**RE: LEIDY SOUTH PROJECT – CLINTON, LUZERNE AND LYCOMING COUNTIES
TECHNICAL DEFICIENCY #2 RESPONSE SUBMITTAL; WATER OBSTRUCTION &
ENCROACHMENT PERMIT; PADEP APPLICATION NO. E1883219-001 (HENSEL
REPLACEMENT AND HILLTOP LOOP), E4083219-001 (COMPRESSOR STATION 607),
E4183219-001 (BENTON LOOP)**

ATTACHMENT A
CHAPTER 105 ADDITIONAL TECHNICAL DEFICIENCY
COMMENT / RESPONSE

Attachment A - Chapter 105 Technical Deficiency #2 Comment / Response

TRANSCONTINENTAL GAS PIPE LINE COMPANY, LLC
LEIDY SOUTH PROJECT - COMPRESSOR STATION 607
SOIL EROSION & SEDIMENT CONTROL PLAN
DETAILS SHEET 2
FAIRMOUNT TOWNSHIP LUZERNE COUNTY PENNSYLVANIA

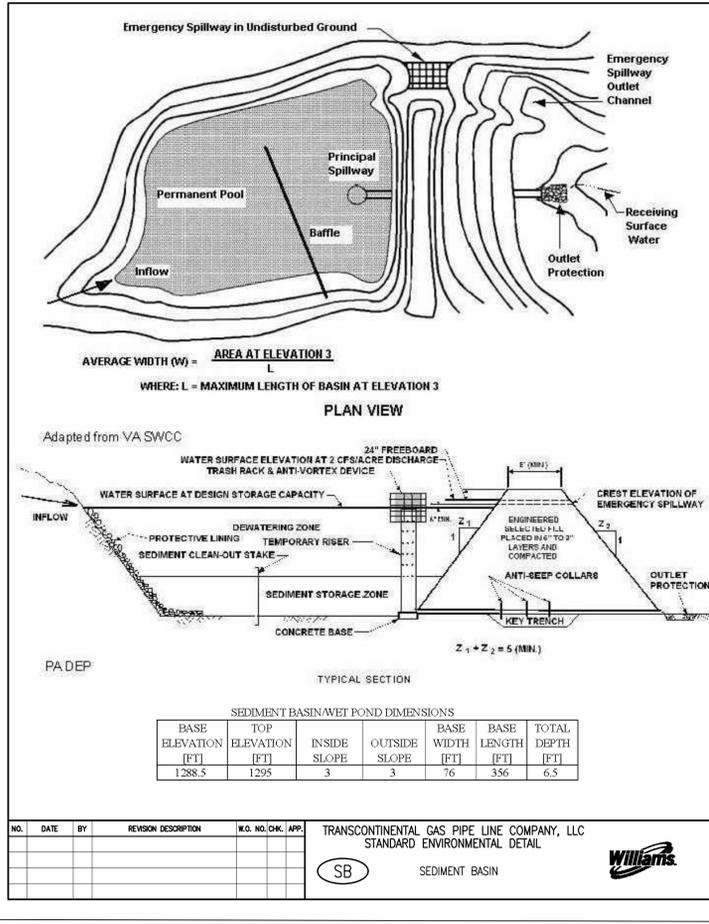
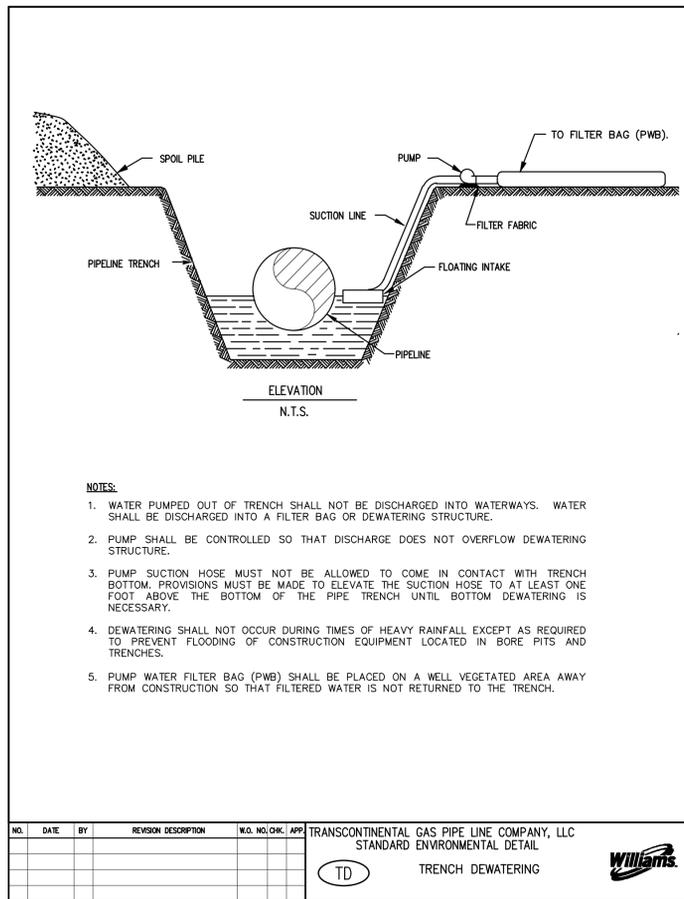
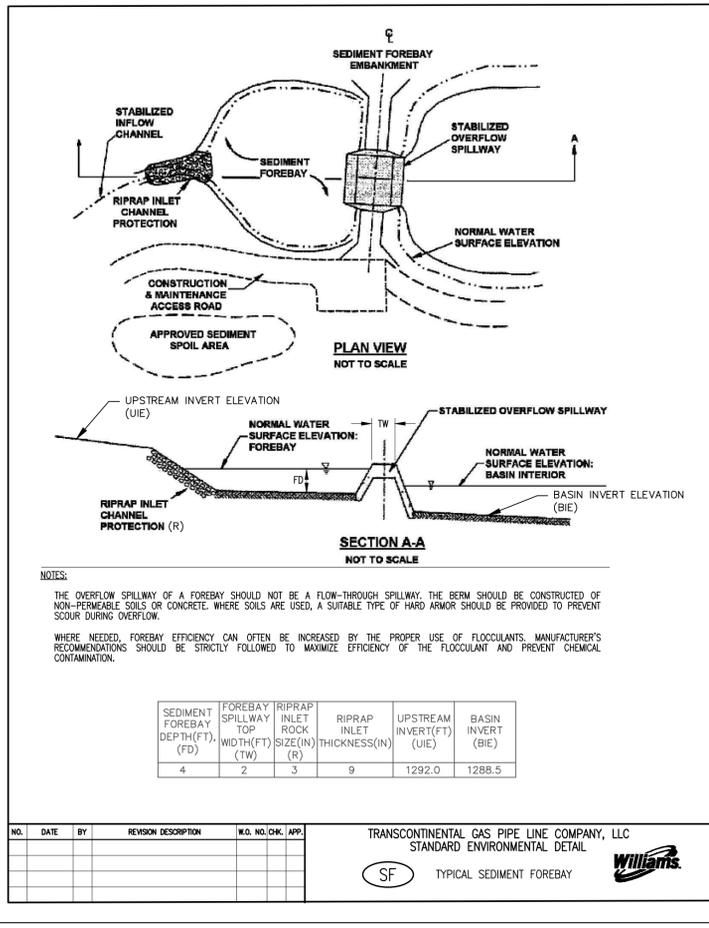
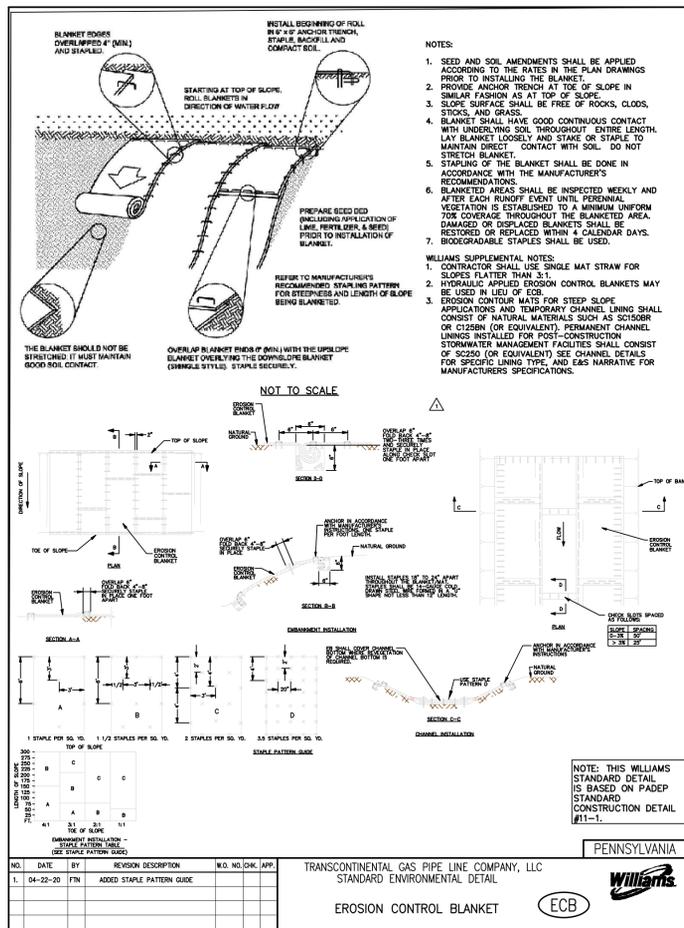
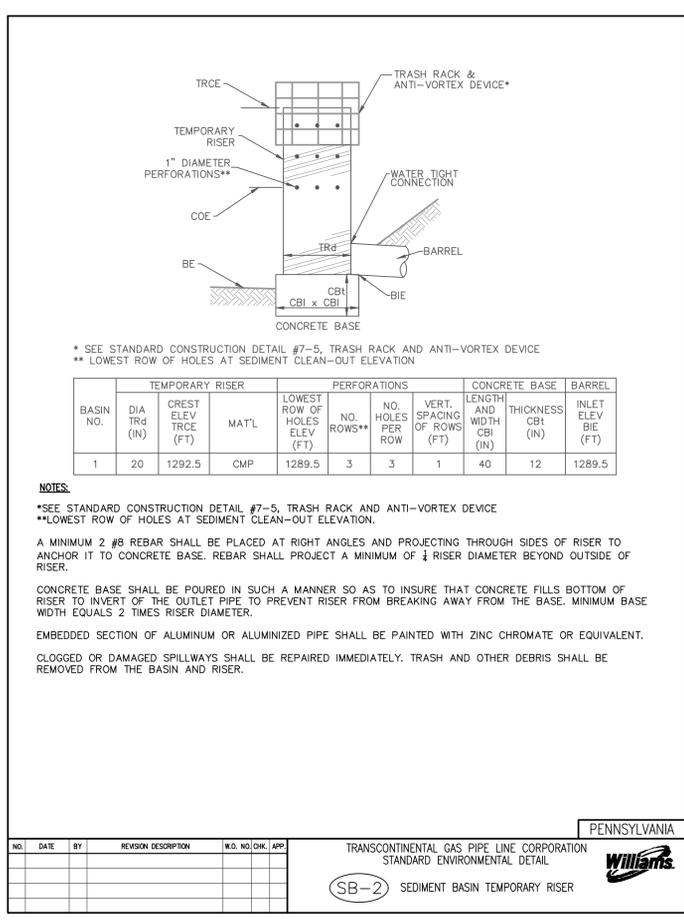
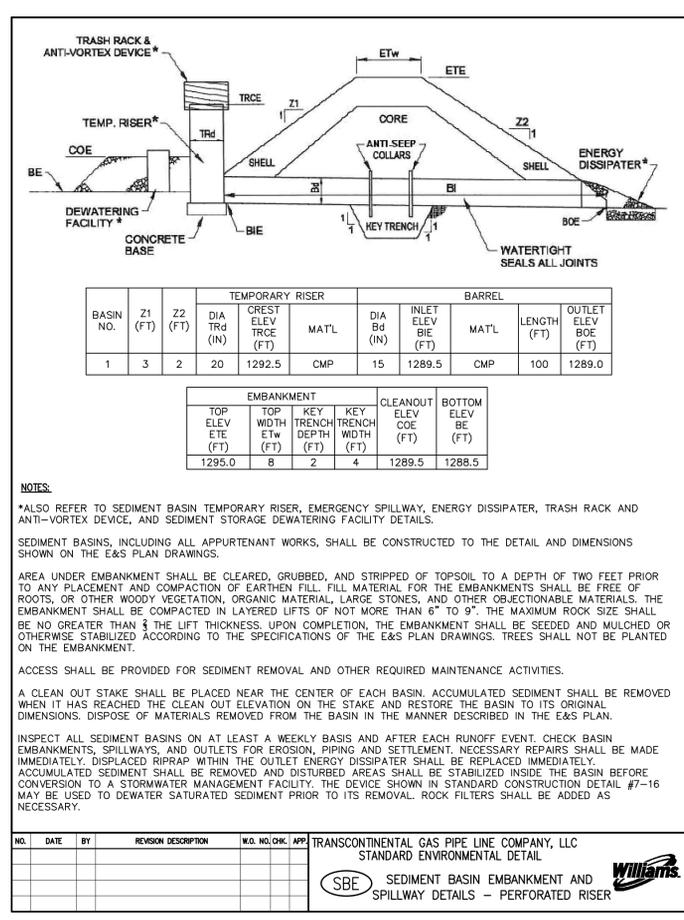
NO.	DATE	BY	DESCRIPTION	W.O. NO.	CHK.	APP.
1	5/04/20	SWH	UPDATED GRADING PLAN TO AVOID / MINIMIZE WETLAND IMPACTS AND PER PADEP COMMENTS
